| Well Name: JICARILLA FLORANCE 'D' | Well Location: T23N / R4W / SEC 6 / NWNE / | County or Parish/State: RIO ARRIBA / NM |

Sundry ID: 2631647

| Type of Submission: Notice of Intent | Type of Action: Plug and Abandonment |

Plug and Abandonment Procedure
for
DJR Operating, LLC
Jicarilla Florance D # 4
API # 30-039-08080
NW/NE, Unit B, Sec. 6, T23N, R04W
Rio Arriba County, NM

Proposed Wellbore P&A Diagram

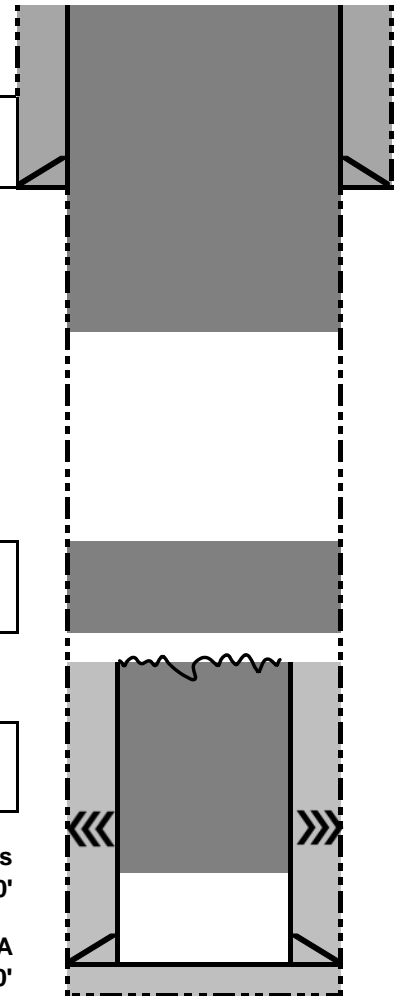
- The plugs proposed in the P&A procedure will adequately protect any freshwater sands in this well bore.
- Pictured Cliffs perms 2512' – 2530'.

You are also required to place cement excesses per 4.2 and 4.4 of the attached General Requirements.
